# UNITED STATES PATENT AND TRADEMARK OFFICE

### Office Action Summary

10/575,258

MIGLI, CARLO

Annotated Fig. 2

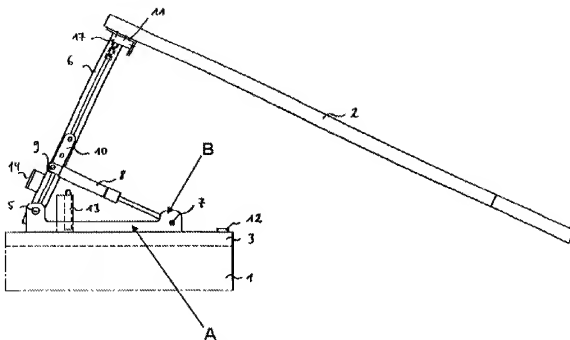
9. For Claim 1, '532 discloses a hinge assembly (Fig. 2) for the connection of a vertically opening panel (2) to an element (1) between a closing position (Fig. 1) and an opening position (Fig. 2) comprising:

a supporting base (annotated Fig. 2: A);

a lifting lever (6) operatively connected to the panel (2) and directly hinged to the supporting base (A) about a first pivoting axis (at 5) between said closing and opening positions of the panel;

a balancing device (8) hinged to the supporting base (A) about a second pivoting axis (7) and acting on the lifting lever (6) along a direction of thrust defined by a line joining the second pivoting axis and a point of application of the thrust on the lifting lever to at least partially counterbalance the weight of the panel during rotation of the lever about said first pivoting axis (as seen in Fig. 2);

wherein the second pivoting axis (7) defines with the first pivoting axis (5) a dead center plane (as seen in Figs. 1-2);

wherein the first pivoting axis (5) and said balancing device (8) are positioned above an upper surface (3) of the element (1) in the mounting position of the hinge assembly (as seen in Figs. 1-2);

wherein in said closing position (Fig. 2) of the panel the second pivoting axis (7) is interposed between the panel (2) and the first pivoting axis (5); and

wherein the direction of thrust of the balancing device during operation is never below said dead center plane (as seen in Fig. 2); and

wherein said balancing device (8) comprises an adjustment device (10) for adjusting the thrusting force exerted by the balancing device on the lifting lever.

27. For Claim 11, '711 teaches the hinge assembly according to claim 10, wherein said hollow body (20) is hinged to at least one supporting wall (22) extending laterally to the supporting base (18). Further, '532 discloses the hinge assembly hinged to a supporting wall (annotated Fig. 2: B) extending from the supporting base (A).
